Issues Matrix for Draft Protocol on Hazard and Risk Analysis

We promised to keep you informed on the progress made in addressing Recommendations 17, 18 and 19, which related to the development and maintenance of a standard methodology for dispersion modelling and risk analysis of sour gas developments. The following table presents the comments received by the EUB on the draft Protocol for Hazard and Risk Analysis. We have also responded individually to each stakeholder whom has commented and have included the EUB responses in the table as well as any follow-up discussions.

Figure 1 - Protocol for Hazard Analysis in Sour Gas Developments

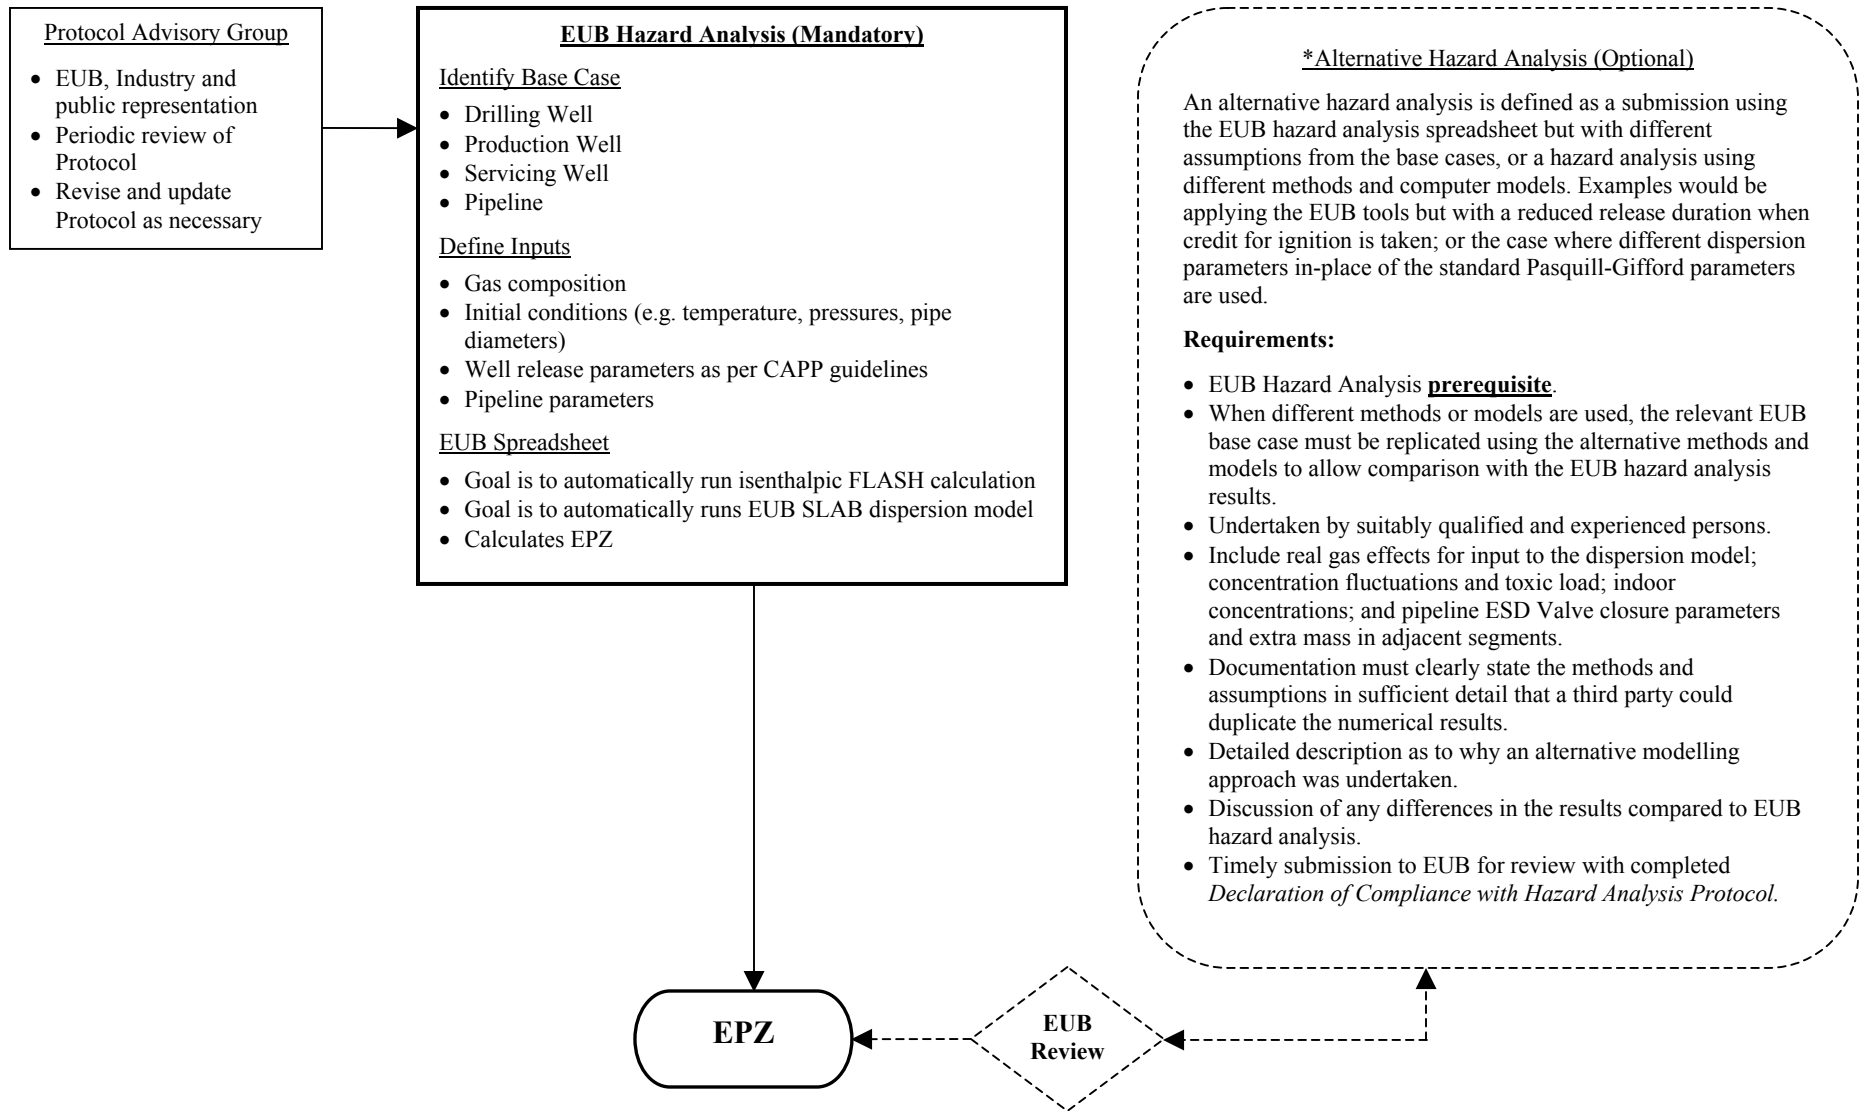
There has also been confusion over what is actually meant by the spreadsheet nomograph and the Screening Hazard Analysis. Due to stakeholder feedback and further discussion, we have revised the Protocol to make it simpler to understand and apply.

The original draft Protocol potentially involved a 2-step process for determining an EPZ. The first step was to use a spreadsheet-based nomograph with conservative simplifying assumptions. If this resulted in an EPZ that was too large for that particular situation, a second step could be applied to refine some of the conservatisms

The draft Protocol also allowed for the submission of an alternative hazard analysis - with certain rules - along with the screening hazard analysis to provide a means for comparison. However, alternate approaches were not allowed to refine the EPZ further. This led to the question as to why an alternative approach was allowed – the answer was so that new science could be introduced ensuring a process by which the Protocol could be changed to accommodate new methods.

As a result of the above issues, the draft Protocol has been changed:

- The determination of an EPZ is now a single stage process. Instead of having a simplified spreadsheet nomograph, the Protocol will require the application of a site-specific hazard analysis. To ensure the objective of having a simple tool, the hazard analysis spreadsheet will only require a user to provide input parameters to derive an EPZ. The running of the FLASH and dispersion model will be automated and not require file manipulation by the user.
- An alternate hazard analysis can now be submitted for EUB review and approval of its EPZ providing the approach meets the criteria defined by the Protocol. In addition, the EUB Hazard Analysis detailed above must still be submitted for benchmarking purposes.
- The process to revise the Protocols regularly will fall to the Hazard and Risk Analysis Advisory Group – a team to be created comprising of EUB, Industry and Public representatives.

The revised process of the Protocol for Hazard Analysis in sour gas developments is shown in Figure 1. A similar process will be defined for risk analysis.
